From: JALOTA Rajesh [mailto:Rajesh.Jalota@ehp.qld.gov.au]
Sent: Friday, 4 April 2014 2:07 PM
To: MCNICOL John; Ivan.Mapp@csenergy.com.au
Cc: HARTIGAN Roger; HARABASZ Samuel
Subject: Possible amendment of Environmental Authorities EPML00417213 (previously MIN10087809) and EPPR00918113 (previously SPDE04947312)

In the recent review of Environmental Authorities of Kogan Creek Mine (EPML00417213 (previously MIN10087809)) and for Ash disposal (regulated waste) EPPR00918113 (previously SPDE04947312), EHP has noticed the following -

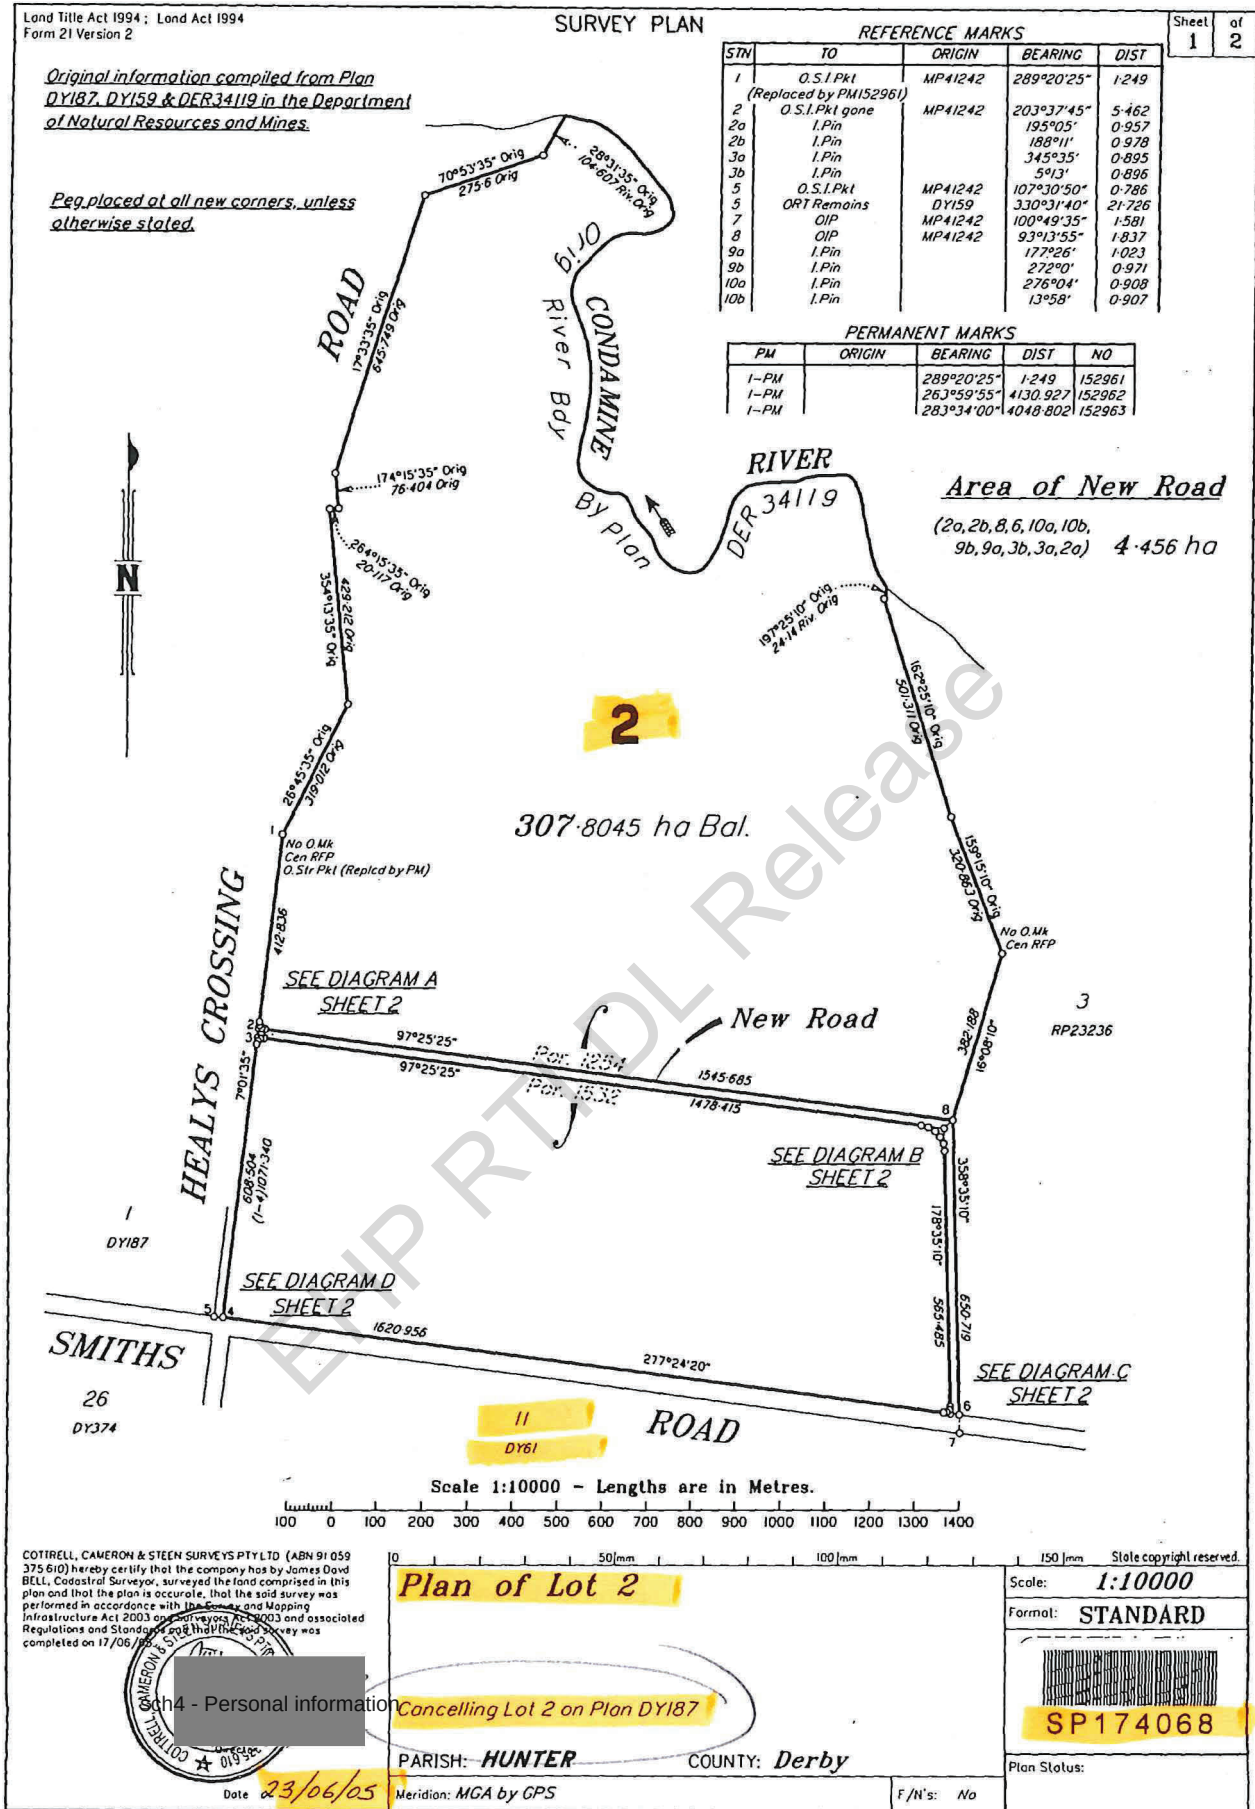
After verifying the locations of hazardous dams as per Environmental Authority EPML00417213, and EPPR00918113 on Queensland Globe (Google maps; attached) I found incorrect coordinates for the following

1. Initial Ash Disposal Area
2. Rom Pond
3. Industrial Pond
4. Bunding Dam and
5. North Evaporation Dam

- Amend Environmental Authority EPPR00918113 to incorporate new lot and plans.
- To avoid any confusion about location and use/nature of hazardous dams, Aberdare Collieries Pty Ltd needs to provide accurate coordinates for all current and future dam sites.
- Aberdare Collieries Pty Ltd needs to clarify if all dams mentioned in the Environmental Authority EPML00417213 and EPPR00918113 have been constructed?
- **If Aberdare Collieries Pty Ltd agree to review and amend the Environmental Authorities EPML00417213 and EPPR00918113.**

Insert Plan Number SP174068

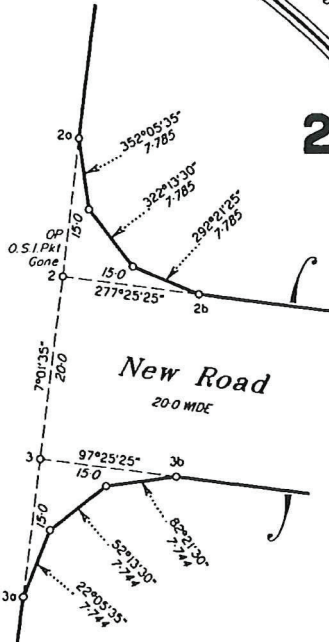
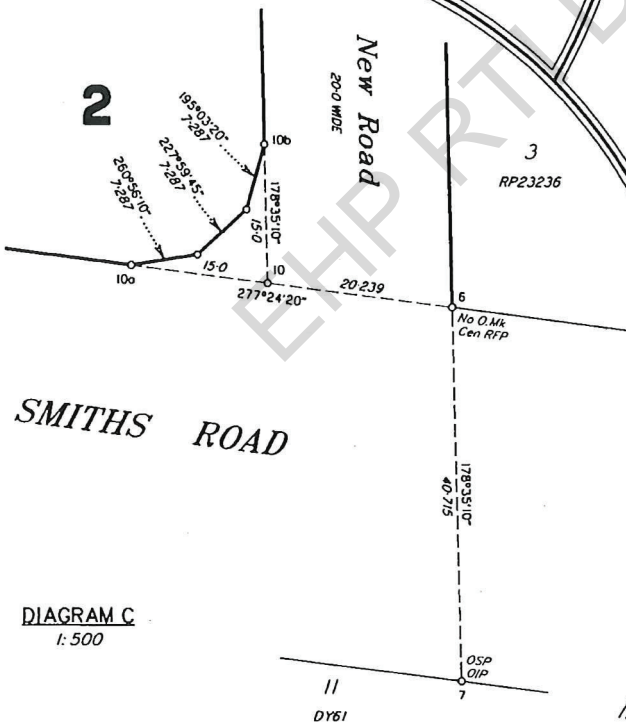
Our database indicate that Lot 2 Plan DY187 and Lot 11 Plan DY 61 have been reconfigured to **Lot 2 on SP174068 and Lot 11 on SP174073**, respectively.
